Title: **Engineering Change Proposal Report for design improvements of the WTP Clarifier and Clarifier chemical dosing** Unique Identifier: **348-10032597**

Alternative Reference Number: **ECP CHEM-01**

Revision: **4**

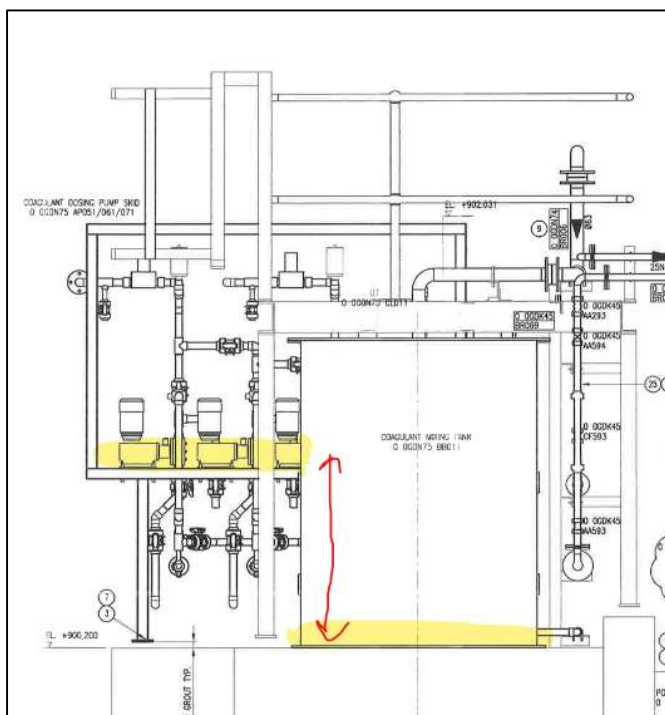
The coagulant dosing pumps suction is placed at approximately 40% of the tank level. Although the pumps are positive displacement pumps, they are unable to pump the coagulant when the level in the tank is below the suction of the pump (see GA figure below). This change report proposes that the pumps suction is dropped or lowered to below 10% of the tank level to allow for the "Low" 15% alarm and "Low Low" 10% level alarm/interlock to be activated during operation as per the design.

- I. It is proposed that the suction point or level of the pumps is decreased to between 5% and 10% to allow for the LL level protection to activate during normal operation.
